CONTINENTAL MOTORS® AIRCRAFT ENGINE
CRITICAL SERVICE BULLETIN

CATEGORY 2
CSB15-7B

SUBJECT: TSIO550-K Oil Cooler Cross Fitting Replacement

PURPOSE: To replace oil cooler cross fitting (P/N AN918-1J) with a new enhanced cross fitting (P/N 658607).

Figure 3. Cross Fitting, Comparison

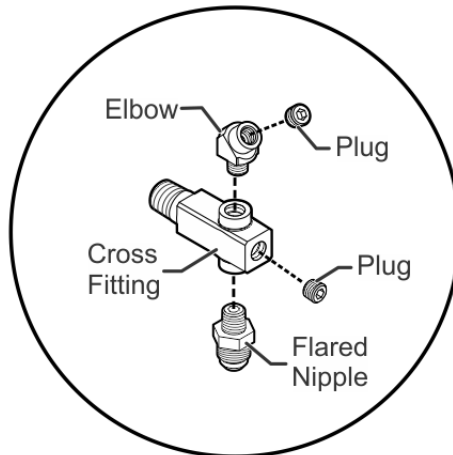
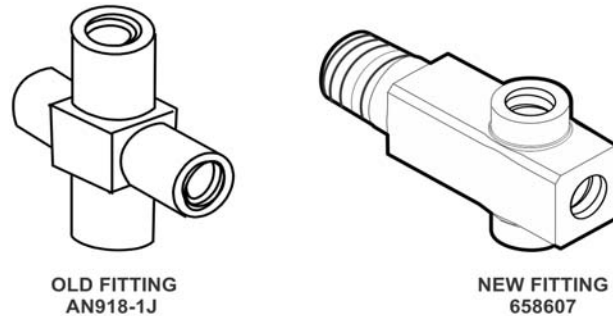
1. Eliminate the pipe bushing and nipple fitting stack-up (see Figure 1) typically found between the cross fitting and the oil cooler and replaces them with a single cross fitting (P/N 658607).
2. Provide a larger tool surface area on the cross fitting for support wrenches during subsequent fitting and B-nut installation.

REMOVE AND REPLACE the superseded parts with new cross fitting (P/N 658607) using the same procedures located in your M-18 Maintenance and Overhaul Manual. Reference the latest revision of the CM Illustrated Parts Catalog (IPC) to determine applicable additional connectors, elbows, or plug part numbers and adjust the instructions accordingly.

Figure 4. Hose and Tube Installation Support

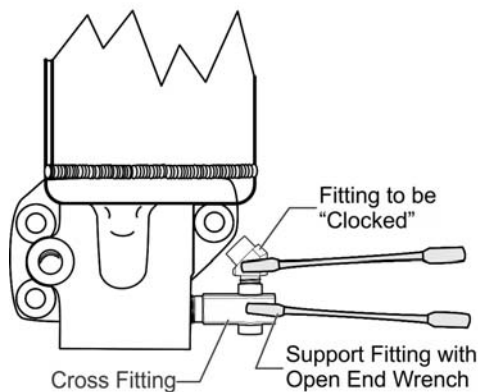
- b. Support the last fitting in the assembly on components that contain multiple fittings coupled in one location (see Figure 4). DO NOT over-torque fittings.
